Staff Report

Item: “Dove Landing” Planned Unit Development (ANX 2020-03)

ANX 2020-03: Analyses & Findings

Image 102B - Dove Landing parkland

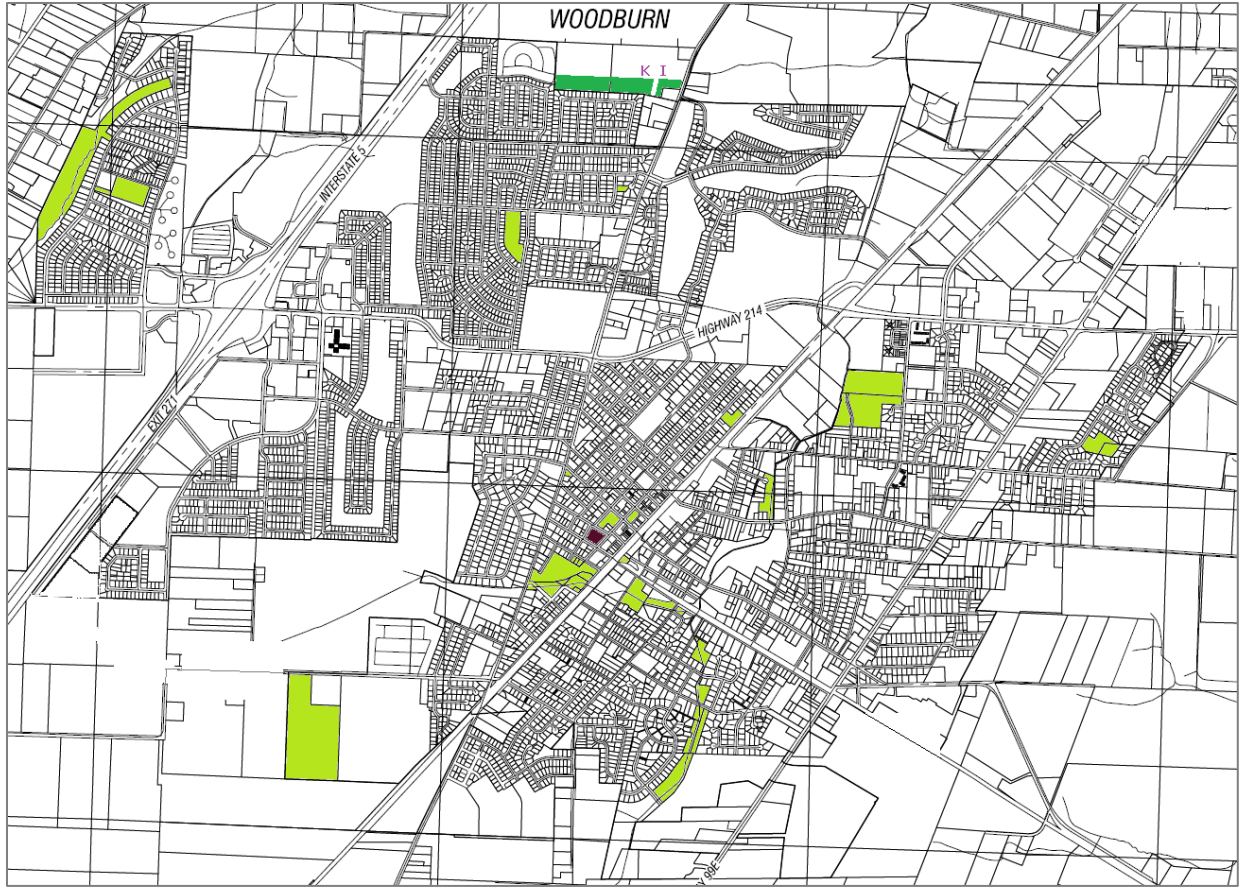
The Dove Landing parkland map represents the City/pub parkland Tracts I & K, which total 8.32 acres, in dark green in relation to existing City parks in light green.

Compared with the Dove Landing site plan, the majority of lots would be beyond the outermost crow-fly buffer of the nearest park, which is Heritage Park. The walking distance of 0.7 miles more than twice exceeds the 0.33 mile buffer distance. Staff emphasizes that access to parks isn't merely about proximity of future residents of Dove Landing to public parks, but also providing adequate parks level of service for existing residents based on the desires and

Image 102D - Parks map "Street Index with Park Buffer": North UGB close-up

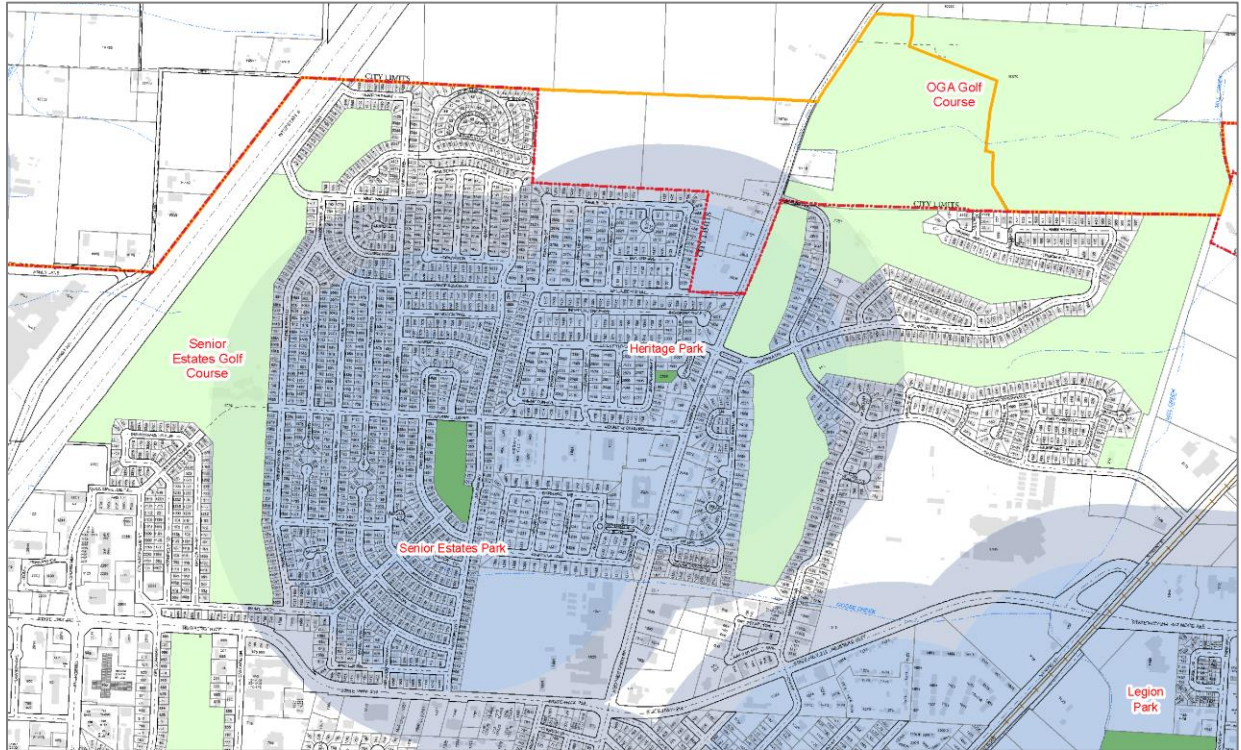
This map shows City parks and walking distance buffers of ¼ and 1/3 miles (blue and gray respectively) in a close-up of the north urban growth boundary (UGB).

Exhibit PUD-3c: Sidewalks (blue: min 8 ft wide)

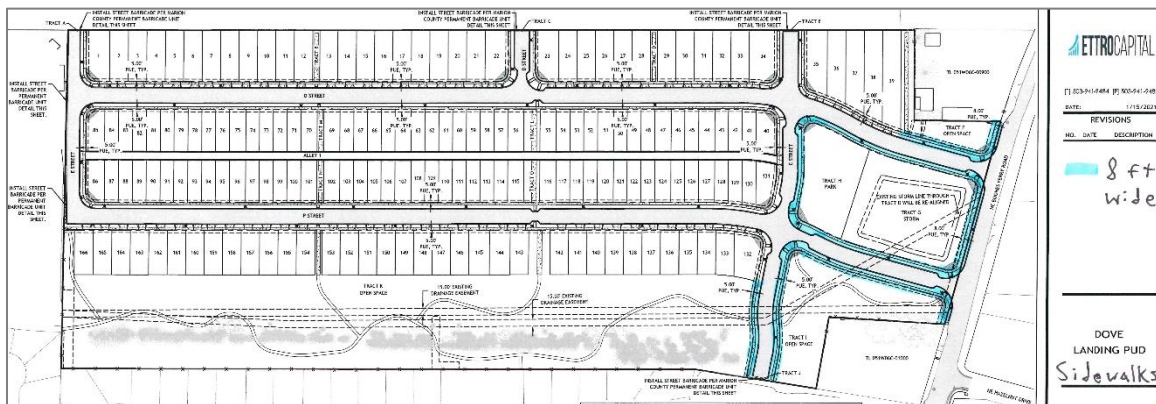
- a. BFR: Per WDO Fig. 3.01C except that planter strip shall be min 6½ ft wide inc. curb width.
- b. Planter strip remainder: Remaining ground not occupied by trees shall be planted with lawn grass.
- c. Sidewalks: Min 6 ft wide except wider as Exhibit PUD-3c supersedes. The BFR sidewalk dead-end(s) and “P” Street west dead-end shall have ADA-compliant transitions spanning between sidewalk and road shoulder. If PW were to direct during CEP review that the road crossing of the culvert have curb-tight sidewalk, min width shall be 8 ft.

Exhibit PUD-3e: Street Tree Min No. (green: equal to 1 tree per 30 ft of block frontage)

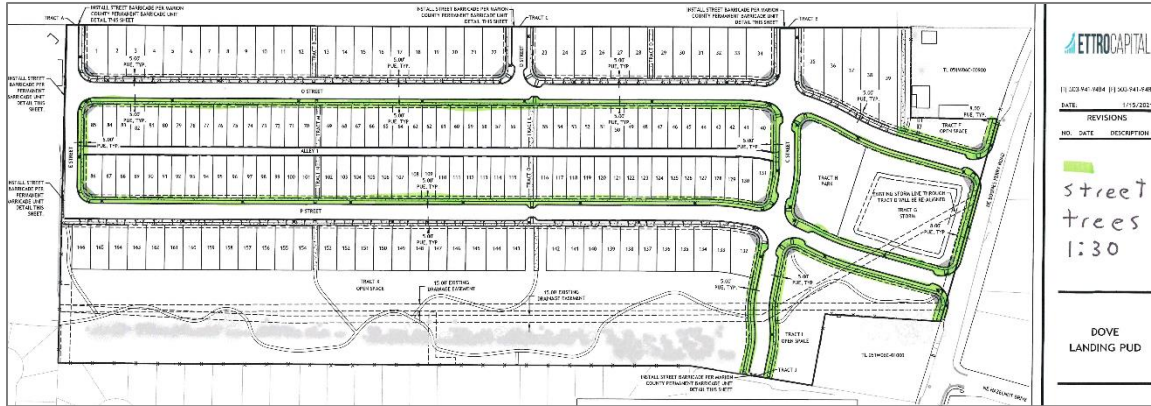
- d. Overlap: The extra width of planter strip and sidewalk shall either (1) overlap outside ROW into streetside PUE and where applicable Tracts I & K or (2) come with additional ROW to accommodate them. Wider sidewalks shall not narrow planter strips.
- e. Street trees: Min numbers equal to block frontage ratios per Exhibit PUD-3e.

Exhibit PUD-3g: Patterned Poured Concrete Crosswalks (symbolized in blue)

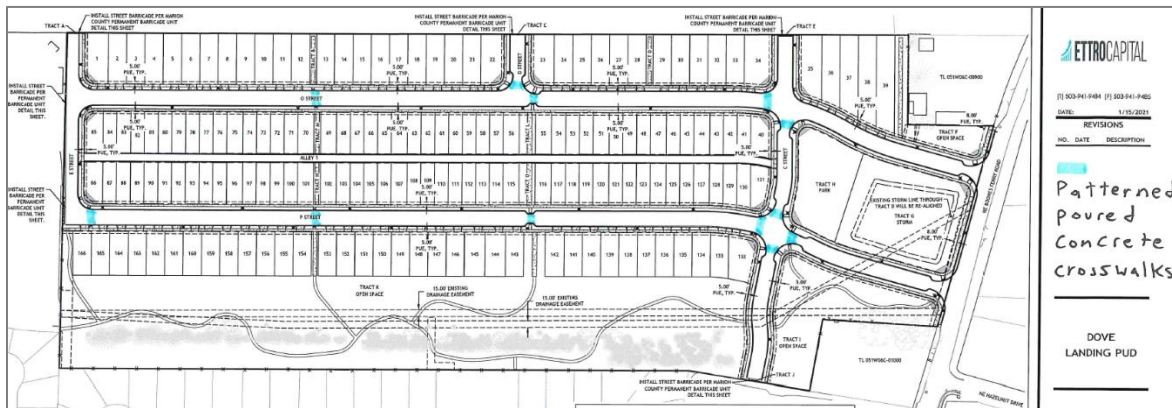
- f. Electric power lines: Electric power lines, whether in or beyond ROW, shall be buried, including those that exist along the BFR frontage.
- g. Traffic calming:
 - (1) Bulb-outs / curb extensions: This condition approves them as land use review Sheet 5 illustrates, except the four along BFR. PW is prohibited post-approval from later eliminating or shrinking the remaining ones as to virtually eliminate them during CEP review and construction. The developer shall submit a fire truck turn radius plan confirming that the extensions are already designed for such if and when PW requests during CEP review.
 - (2) Crosswalks / pedestrian crossings along intersection legs per Exhibit PUD-3g shall be patterned poured concrete each min 8 ft wide.

CONCEPT
SITE PLAN
ALTERNATIVE 2

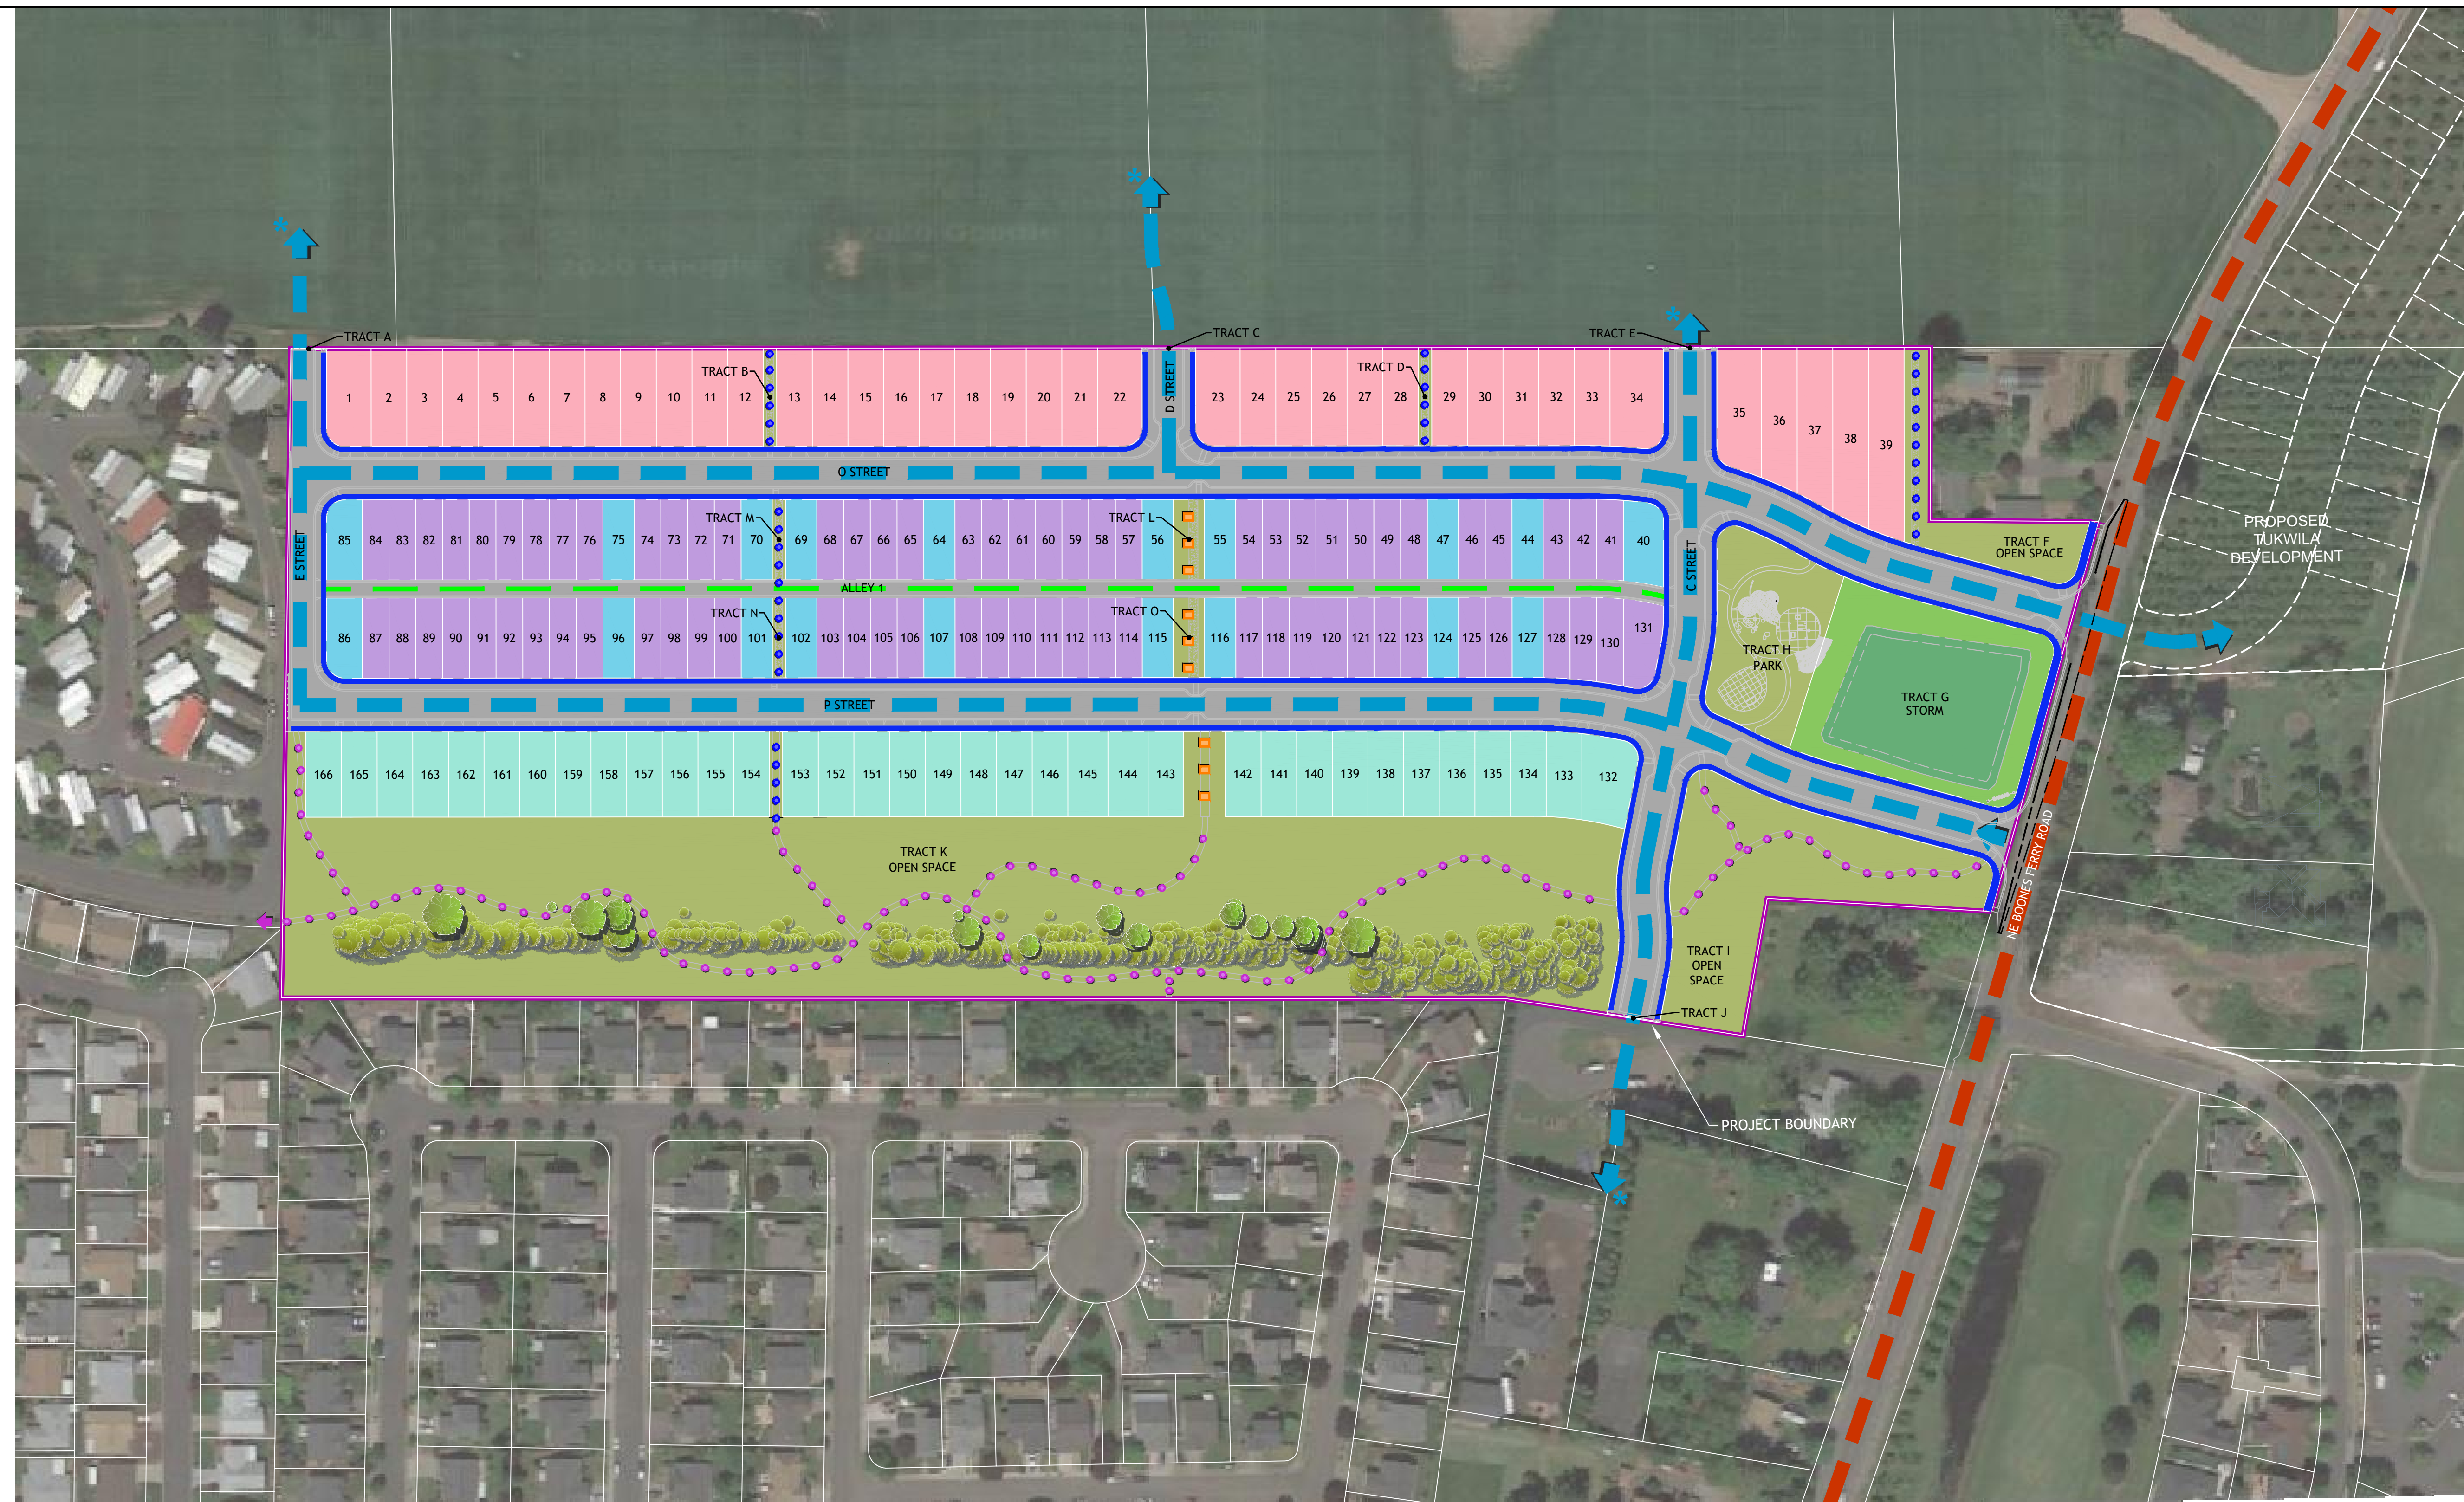
The total 8.32 acres of Tracts I & K, with Tract K being the larger one at 7.2 acres, appeals to the Assistant City Administrator as parks director in that the size can easily fit regional facilities were the City to later construct or install them. The two tracts are 26.7% of the gross site area in the context of PUD standard of 30% open space. The remaining tracts as common areas compose the total of 33% per land use review plan Sheet 4 that the developer proposes as open space.
